**VALUE ENGINEERING STUDY
OF
RECONSTRUCTION OF I-64/
KY 180 INTERCHANGE
Item Number: 9-60.00**

**Boyd County, Kentucky
October 17-21, 2005**

**Prepared by:
VENTRY ENGINEERING, L.L.C.**

**In Association With:
KENTUCKY TRANSPORTATION CABINET**

**1-64KY 180 INTERCHANGE
LIGHTING PLAN**

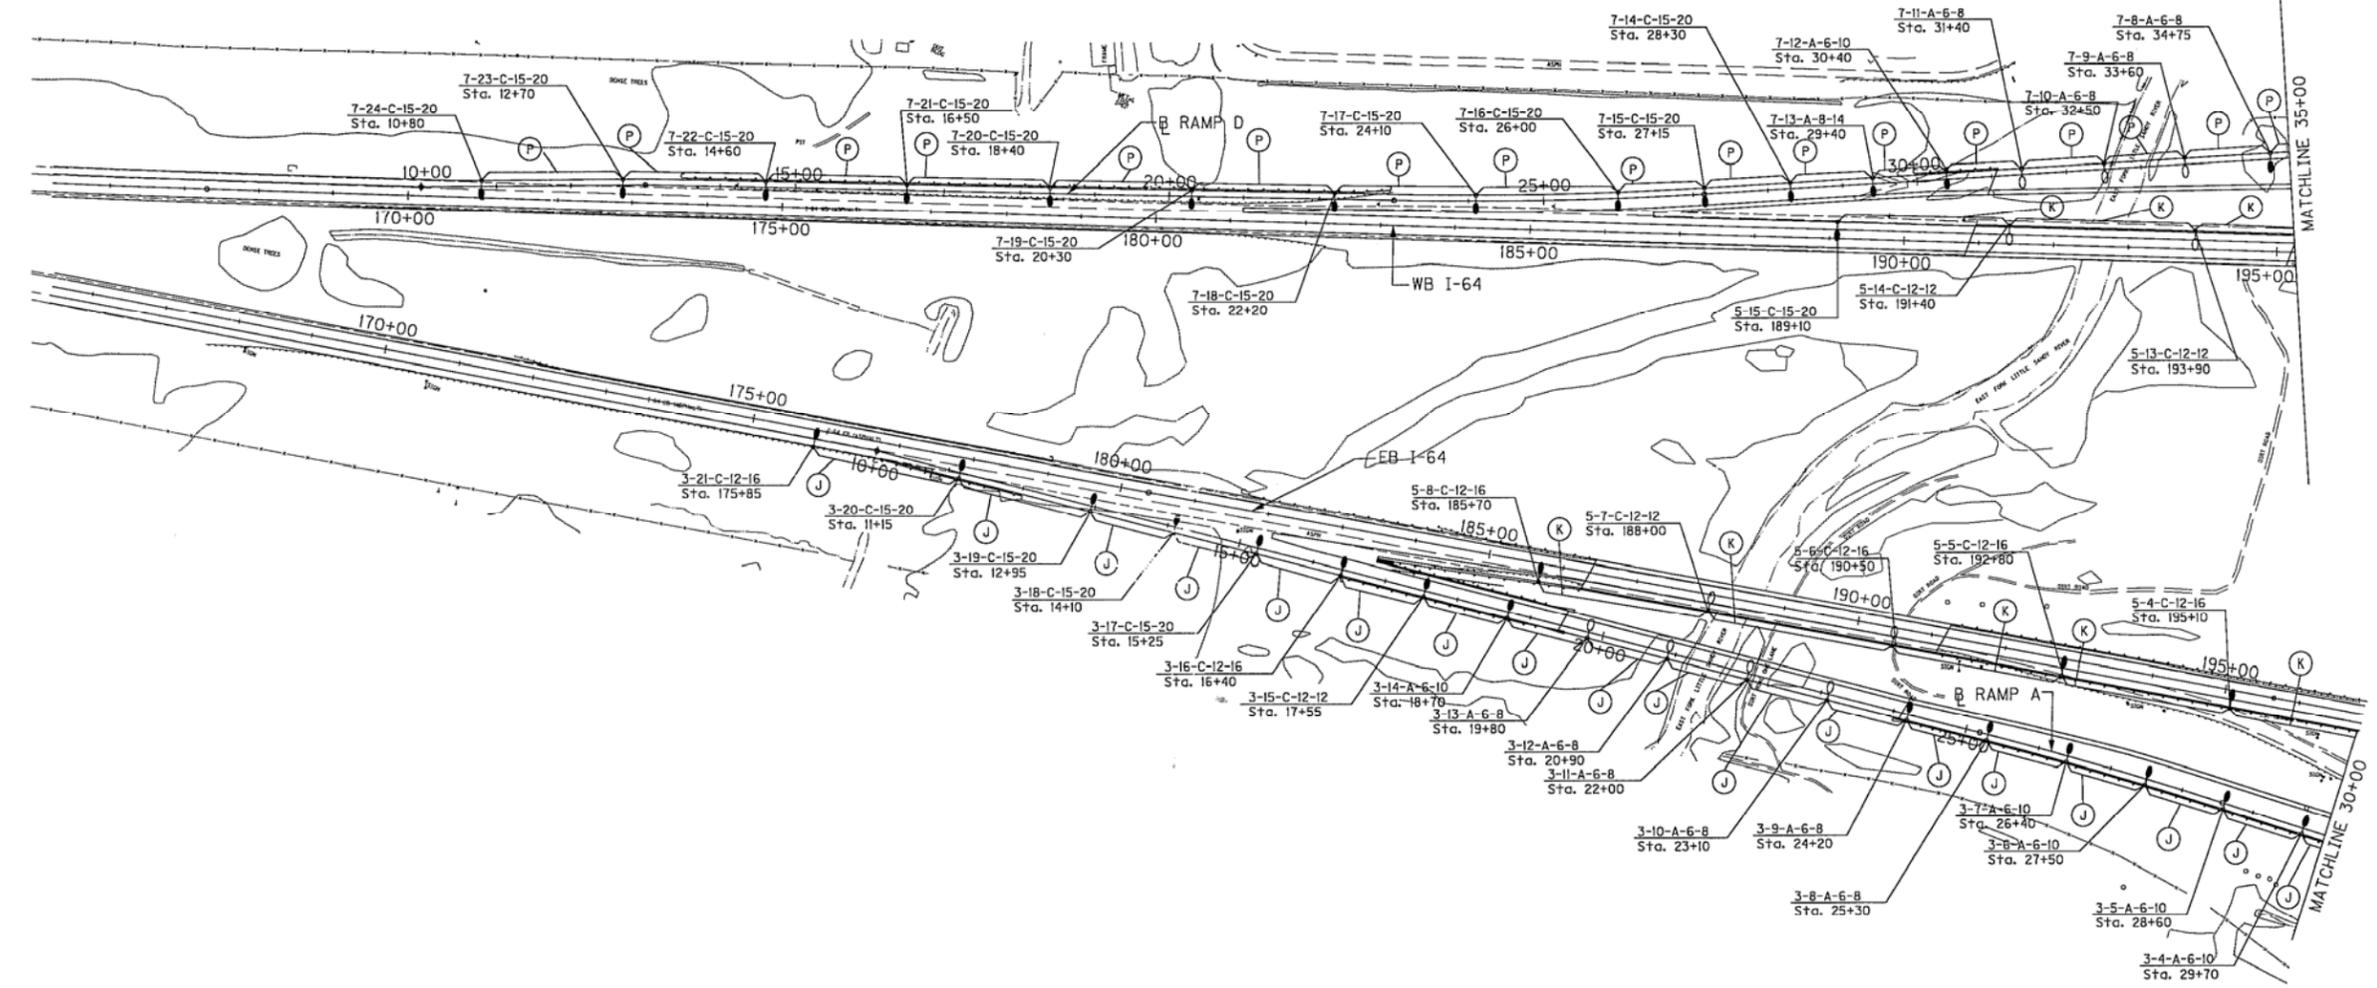
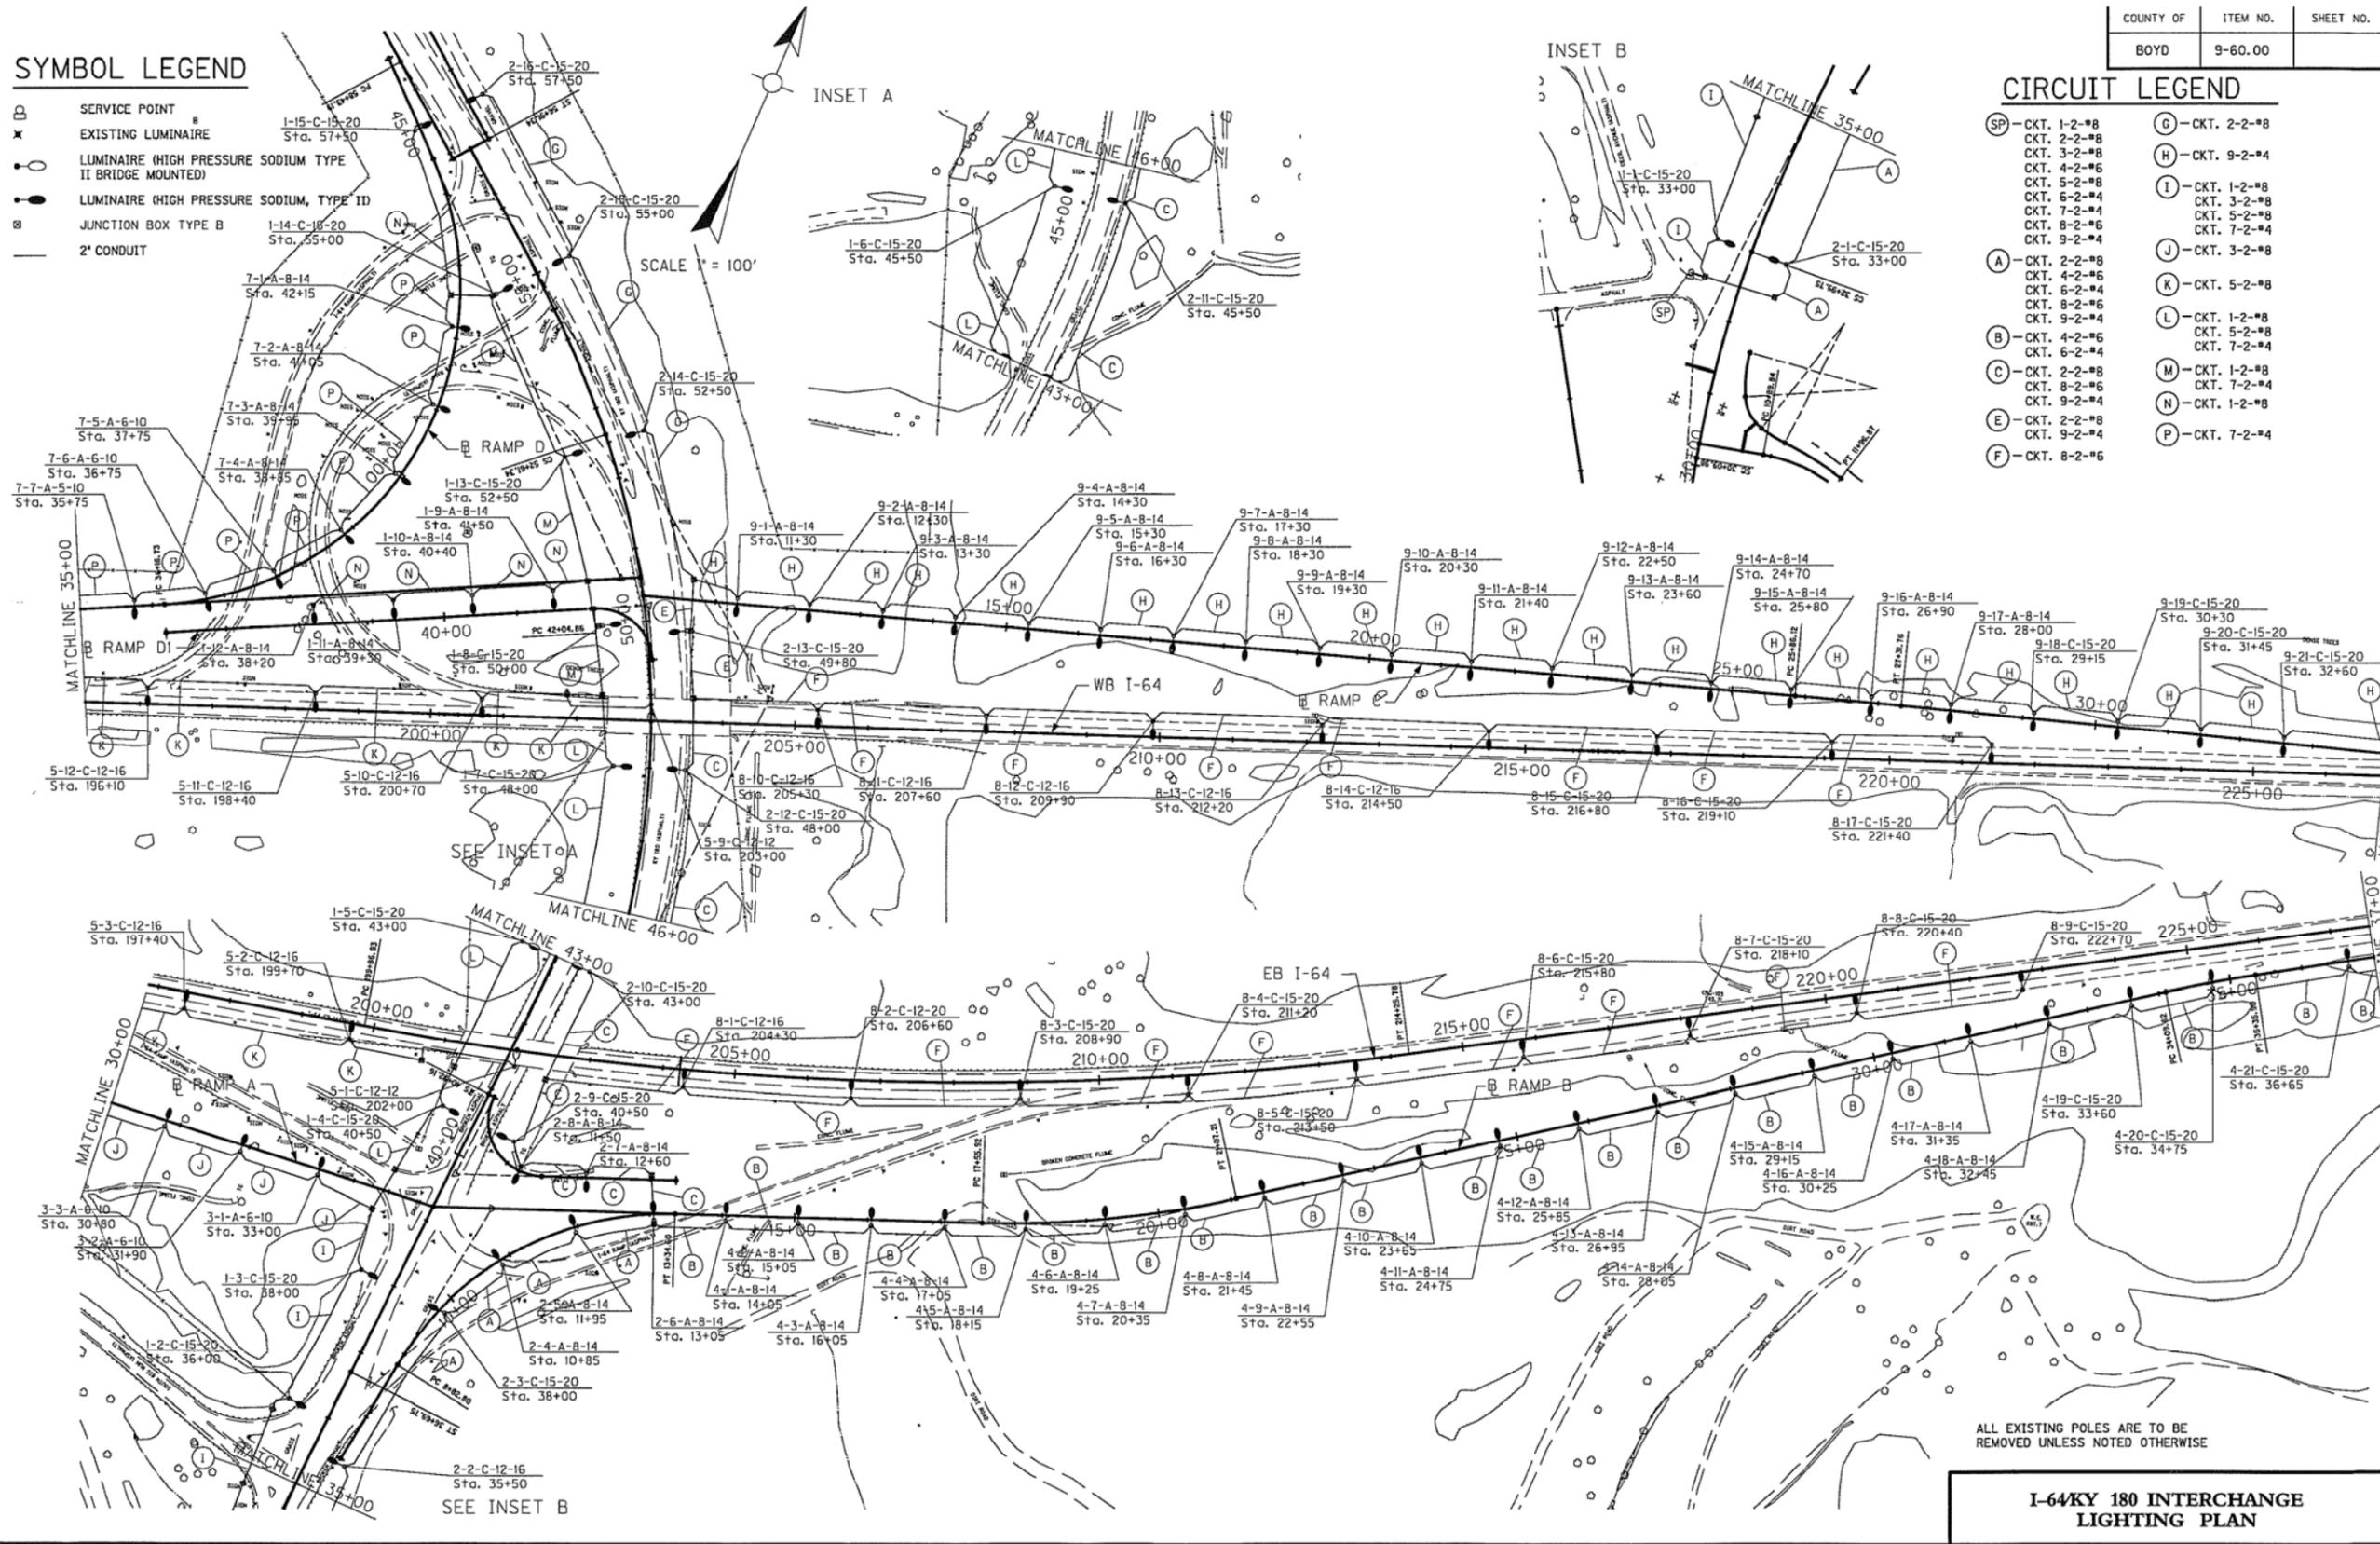
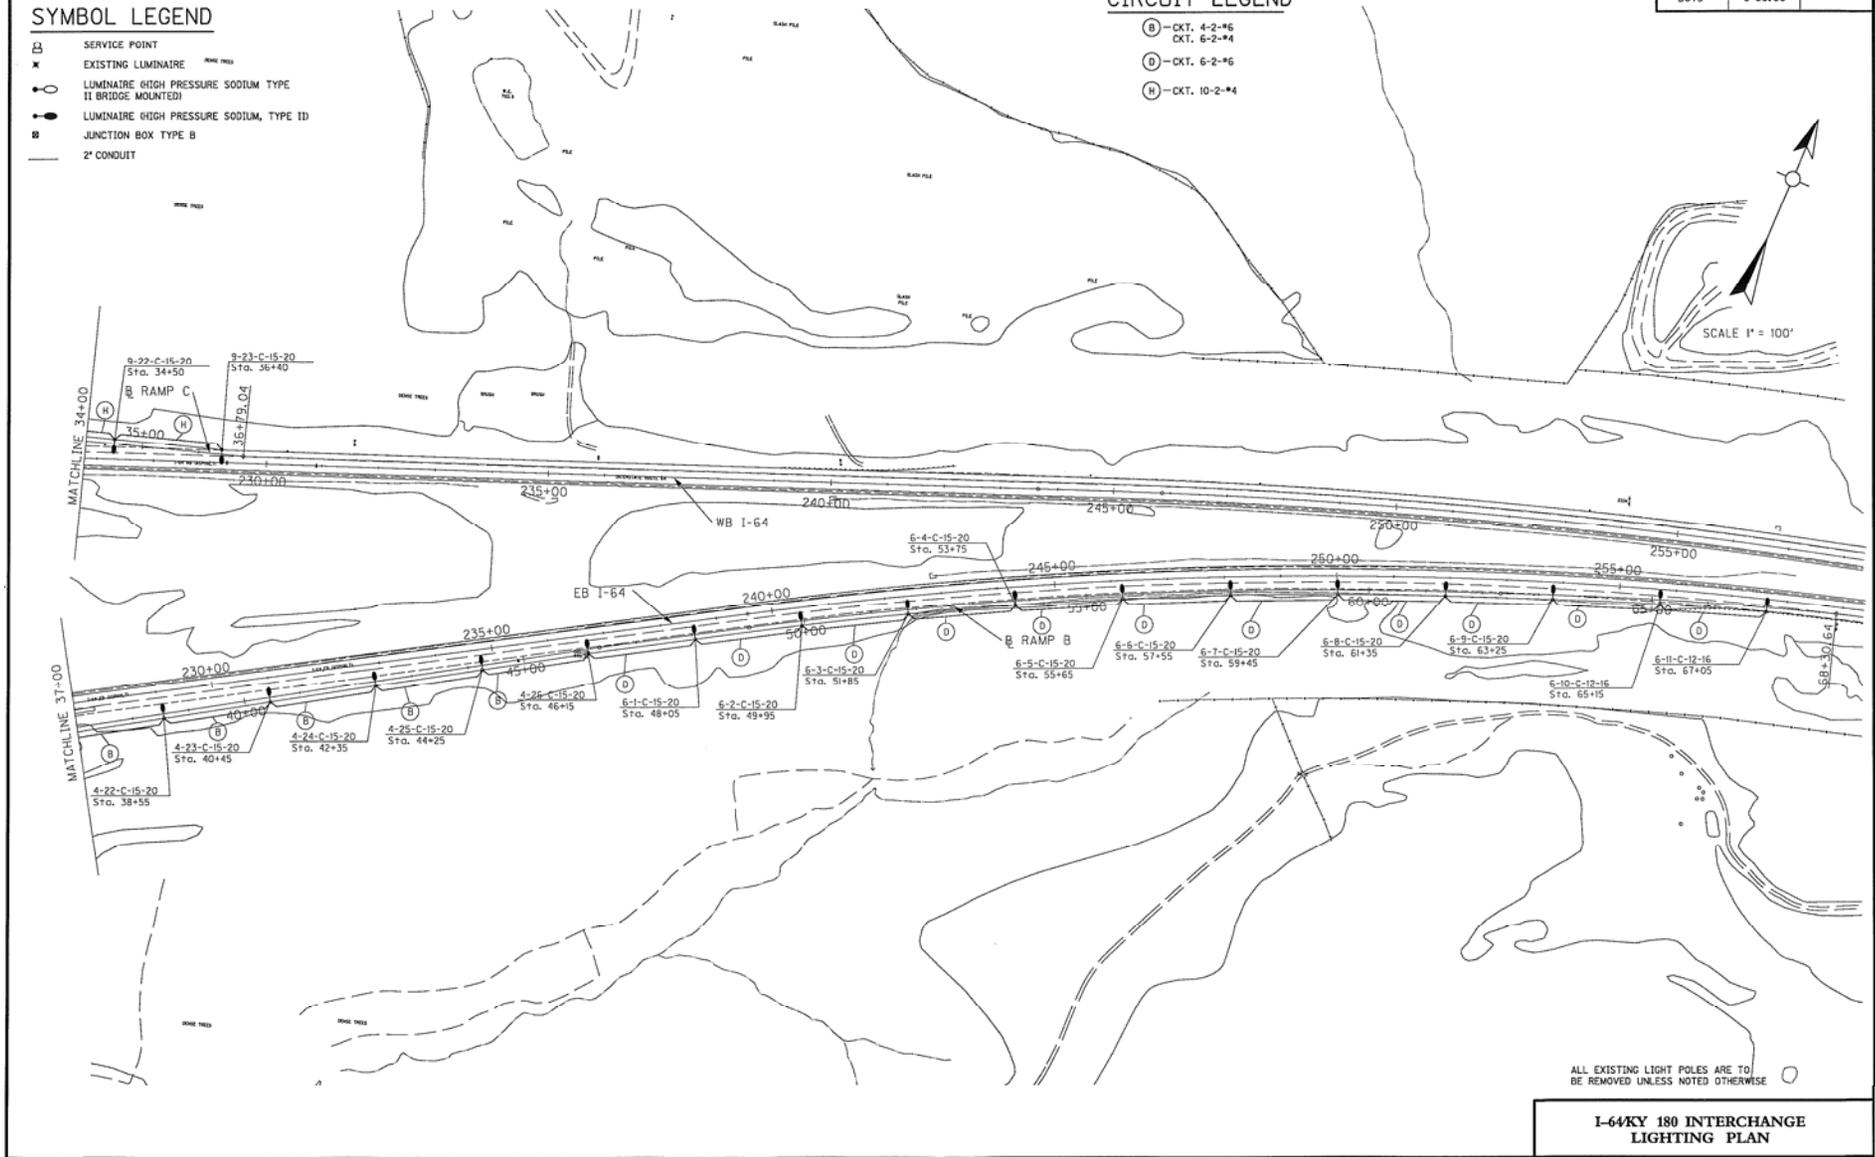
Change the permanent lighting design to 100 ft. and 120 ft. high mast lighting. There is no change proposed to the temporary lighting plan, except where the designer intends that the permanent lighting be installed early to provide lighting during maintenance of traffic operations.
